Service Bulletin

Bulletin No.: 19-NA-070

Subject: Squeaking/Creaking Noise from Rear Suspension When Driving on Rough Roads or Over Bumps

Brand:	Model:	Model Year:		VIN:		Engine:	Transmission:
		from	to	from	to		
Chevrolet	Blazer	2019	2019			All	All

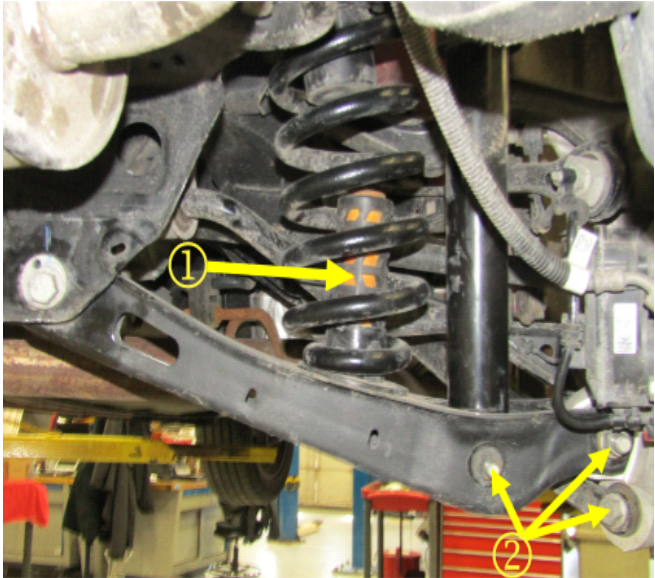
Involved Region or Country	North America, N.A. Export Regions
Additional Options (RPOs)	Equipped with WHEEL-21 X 8.5, J, ALUMINUM, DESIGN 1 (RQM) or WHEEL-21 X 8.5, J, ALUMINUM, DESIGN 2 (ROY)
Condition	Customer may comment on hearing a squeak or creak type noise coming from the rear suspension, when driving on rough roads or over bumps. The condition can occur on the driver, passenger, or in some cases, both sides.
Cause	The cause of the condition may be a poor interface between the lower control arm and the rear suspension jounce bumper.
Correction	 <p style="text-align: right;">5310094</p> <p>Note: When removing the spring(s) to access the rear suspension jounce bumpers (1), it will also be necessary to replace 3 single - use fasteners (2), per side.</p> <p>Verify which side, or both, are affected and replace the rear suspension jounce bumpers (1), on those sides. Refer to <i>Rear Coil Spring Replacement</i>, in SI.</p>

Causal Part	Description	Part Number	Qty
X	BUMPER ASM-RR SUSP JOUNCE	84181736	1 or 2, as necessary
N/A	BOLT/SCREW	11610869	
	BOLT/SCREW	11611841	
	BOLT/SCREW	11610911
